Re: Response to Agency (Ku-ring-gai Council and OEH) comments – Lindfield Learning Village (SSD 8114).

This letter has been prepared in response to the comments made by Ku-ring-gai Council (Letter to Teresa Gizzi dated 17 July 2018) and the Office of Environment and Heritage (OEH) (Letter to Karen Harragon dated 19 July 2018) to a Biodiversity Assessment Report (BAR) prepared by Ecoplanning for the above development (report dated 1 June 2018). A response is provided for each of the comments below (**Table 1**).

Figure 1: Survey effort.

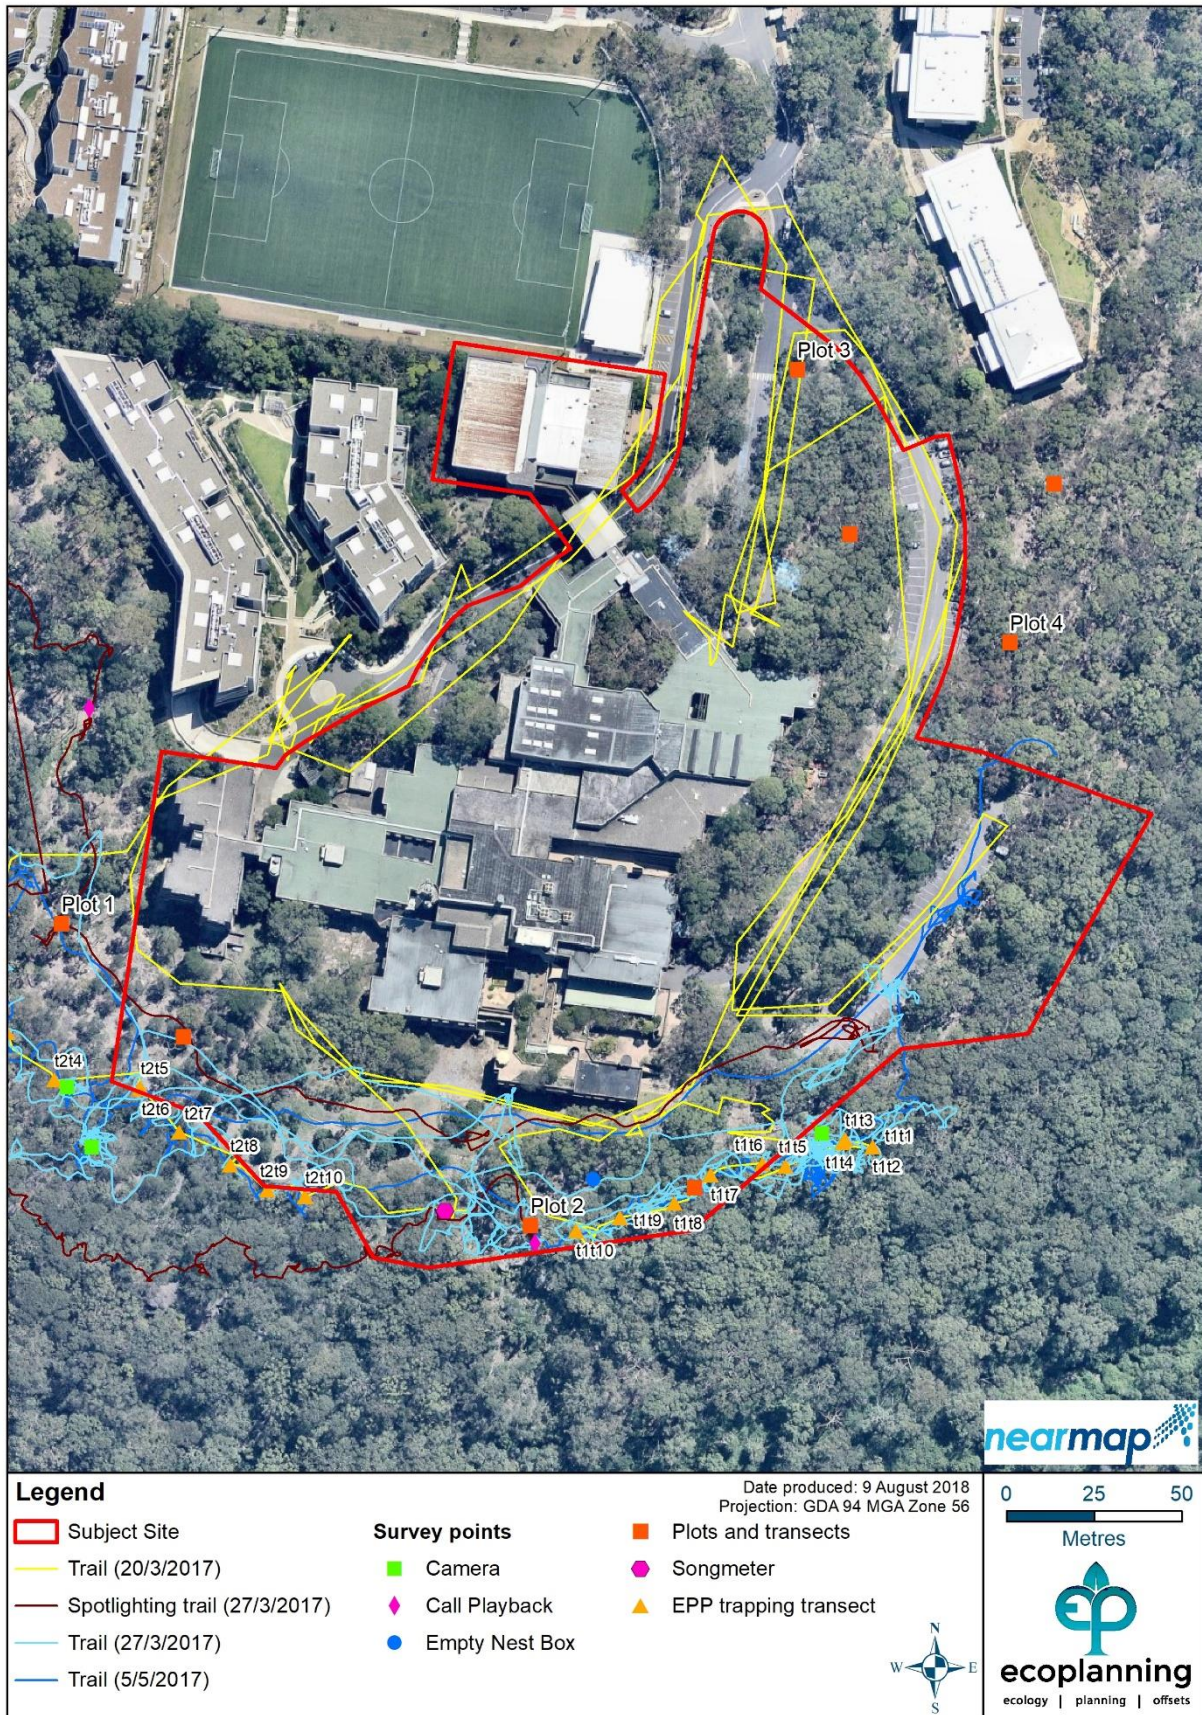
Ku-ring-gai Council Comments	
Comment	Response
<p>The Biodiversity Assessment Report (BAR) prepared by eco-planning consultants assumes the absence of threatened fauna (species) as none were detected within the development area at the time of the fauna surveys.</p> <p>A detailed flora and fauna investigation was undertaken ERM Australia over the former University Technology, Sydney (UTS) site as part of the part 3a concept plan approval (Application Number: 06_0130).</p> <p>ERM Australia whom prepared the flora and fauna assessment recorded the following threatened species: <i>Darwinia biflora</i>, Red-crowned Toadlet and Powerful Owl within the UTS site.</p> <p>The habitat/vegetation to be removed as a result of the proposed development and the asset protection zones provides known habitat for these species. The BAR fails to provide any species credits to offset the loss of habitat as a result of the proposal. An amended BAR should provide species credits to offset the loss of known habitat for <i>Darwinia biflora</i>, Red-crowned Toadlet and</p>	<p><i>Darwinia biflora</i> is not considered a species credit species as it is not a candidate species for either of the two PCTs identified within the subject site. Given that ERM (2004) recorded the species close to the current subject site Ecoplanning conducted numerous targeted flora surveys across the subject site (Figure 1):</p> <ul style="list-style-type: none"> • 24/03/17 - 7 hours, Lucas McKinnon • 27/03/2017 - 6 hours, Tom Hickman • 5/05/2017 - 17 hours, Tom Hickman and Tammy Paartalu • 23/11/2017 - 2.5 hours, Tammy Paartalu <p>Ecoplanning botanists (Tammy Paartalu and Tom Hickman) identified and counted a number of <i>Darwinia biflora</i> outside of the subject site to the east of Charles Bean oval but no individuals were recorded within the subject site.</p> <p><u>Red-crowned Toadlet</u> Survey effort for the species is specified in Table 4.3 of the BAR and included call playback</p>

Powerful Owl.	<p>conducted over two survey nights on 27/03/2017 and 12/04/2017. Daylight survey was conducted in all areas of potential habitat, including intermittent drainage lines with a build-up of litter or other debris. The location of call playback was outside of the subject land to the west, prior to knowing the current extent of the direct footprint, but within the APZ (Outer Protection Area).</p> <p>Additional survey is not considered necessary.</p> <p><u>Powerful Owl</u> is not considered a Species credit species following assessment of geographic and habitat features in the credit calculator. Essentially this means there are no hollow bearing trees to constitute suitable breeding habitat within the subject site. The subject site represents foraging habitat only. Powerful Owl is, is considered an Ecosystem credit species for foraging habitat and has been treated as such in the BAR.</p>
